MEMORANDUM

Re: Albemarle Playground North & Multi-Use Path

**ALBEMARLE PARK**  
**NEWTON, MASSACHUSETTS**

SUBMITTED TO:  
NEWTON CONSERVATION COMMISSION

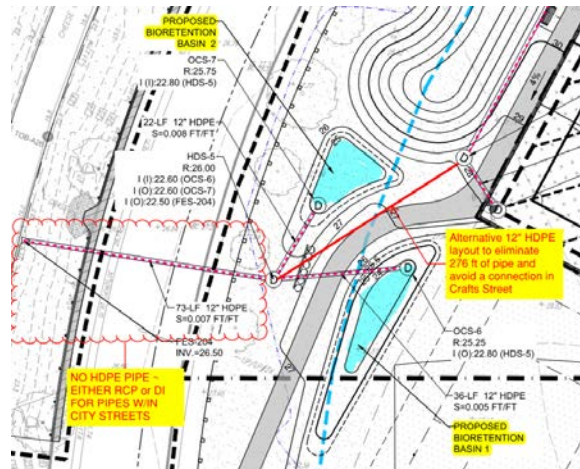
The new overflow pipe to Cheesecake Brook as shown as HDPE, this is not permitted within City street; the overflow pipe shall be either reinforced concrete pipe type 4 or ductile iron pipe class 52.

*Crafts Street looking southerly toward the park, no sign of the manhole as shown on sheet C-100.*

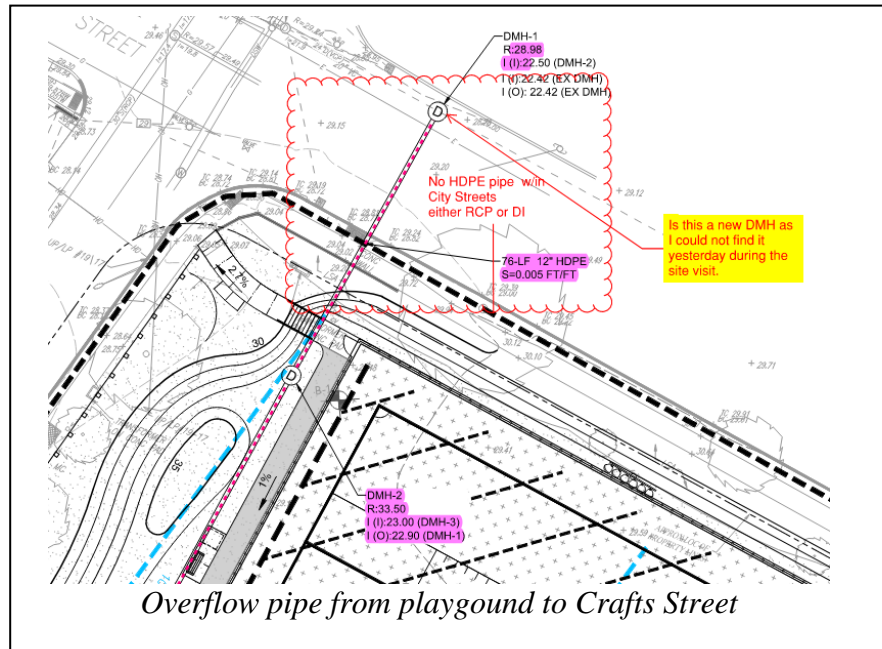
In the snapshot of sheet C-100 following, shows a 12” overflow pipe from the southwest corner of the soccer field heading towards Crafts Street; approximately 276-feet of pipe. Based on a site visit yesterday the drain manhole shown on the plan did not exist within Crafts Street. I would recommend that the 276 feet of pipe be eliminated and connected to the proposed overflow to Cheesecake Brook.

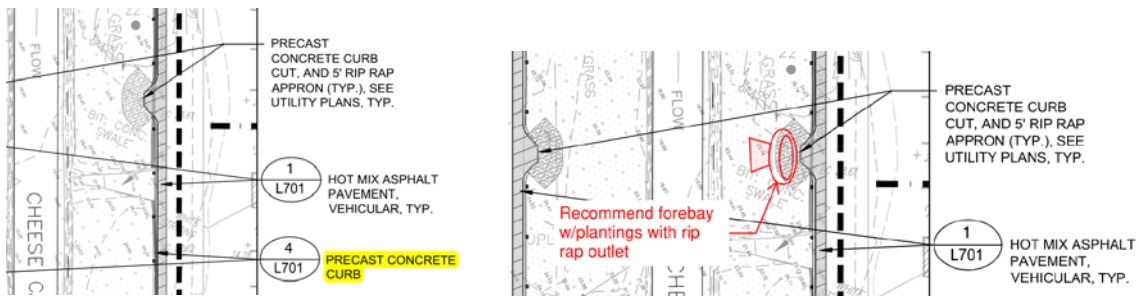
Within the project limits parallel to the edge of Albemarle Road and between the Cheesecake Brook the plan indicates that a new wood guard rail will be installed, and the asphalt curbing shall be removed, and new precast concrete curbing will be installed. The DPW standard for new curb installation is granite curb. The issue with precast concrete curb is during snow removal operations it is more than likely plows may inadvertently damage the concrete curb; and eventually the concrete curb will fail and deteriorate with road salt intrusion. DPW strongly recommends that for longevity performance of the curbing and its design intent it should be installed as standard *granite* curbing and NOT precast concrete.

**1** COLLECTOR DRAIN/ LATERAL DRAIN CONNECTION AT NATURAL TURF FIELD  
SCALE: N.T.S.

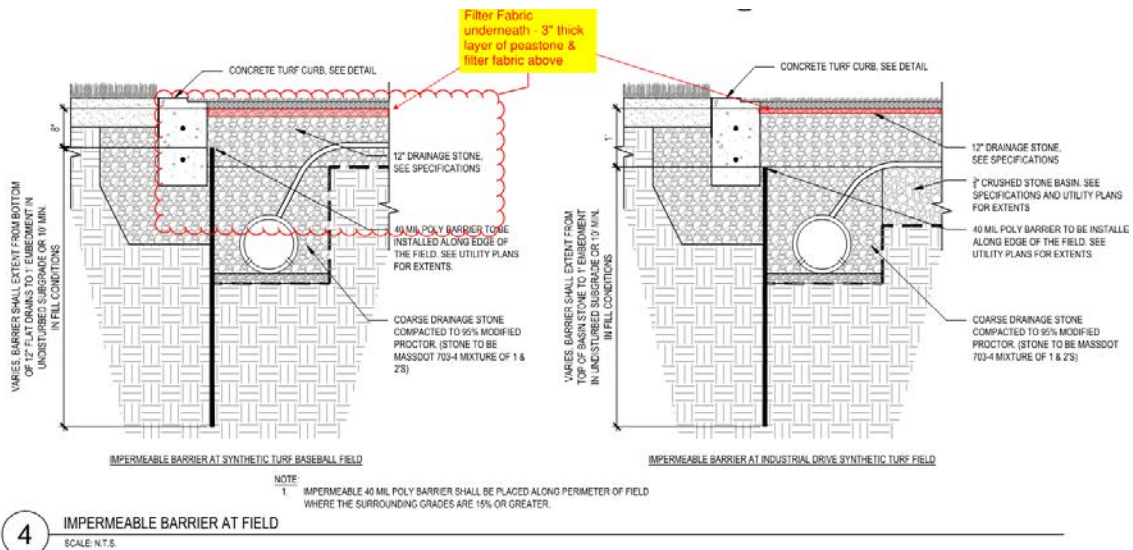
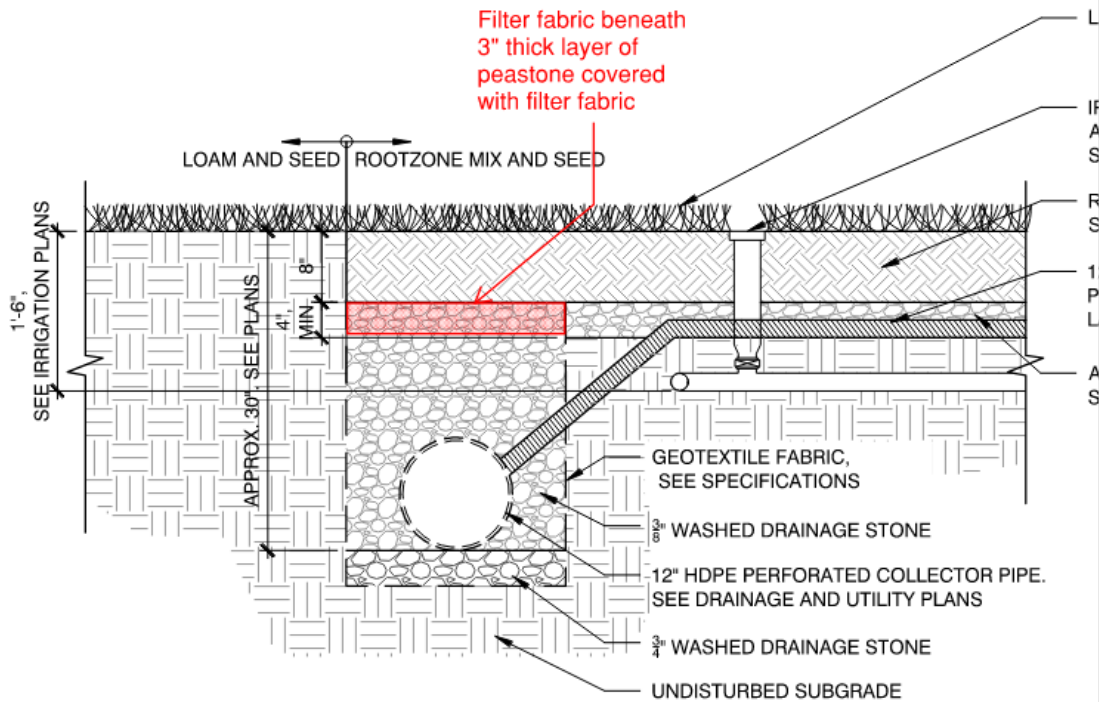
The detail for the impermeal barrier and collector drain should have filter fabric placed over the stone, then a 3” thick layer of Peastone and cover with filter fabric to prolong the performace life.

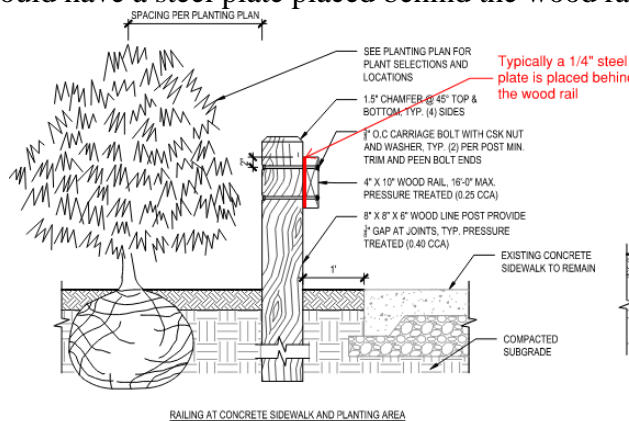
The railing detail should have a steel plate placed behind the wood railing.

5 TRENCH DRAIN DETAIL  
SCALE: N.T.S.

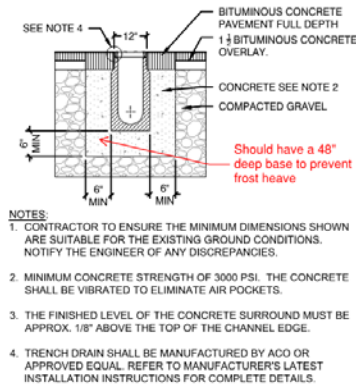
To prevent frost heaving of the trench drain it should have a 48" deep compacted gravel base.

7 BIORETENTION AREA  
SCALE: N.T.S.

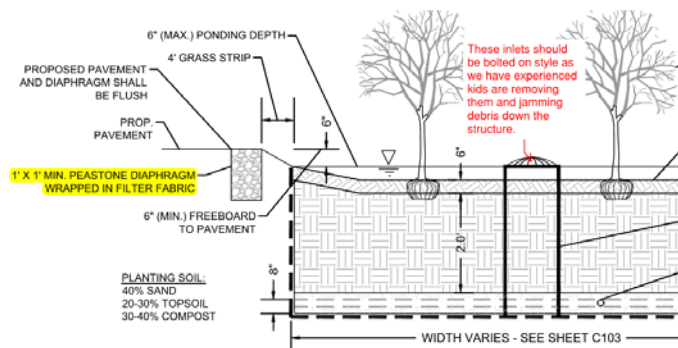
DPW recommends that the proposed inlets to the area drains be bolted type grates, as kids have removed them and stuffed debris in the structure on a few school properties.
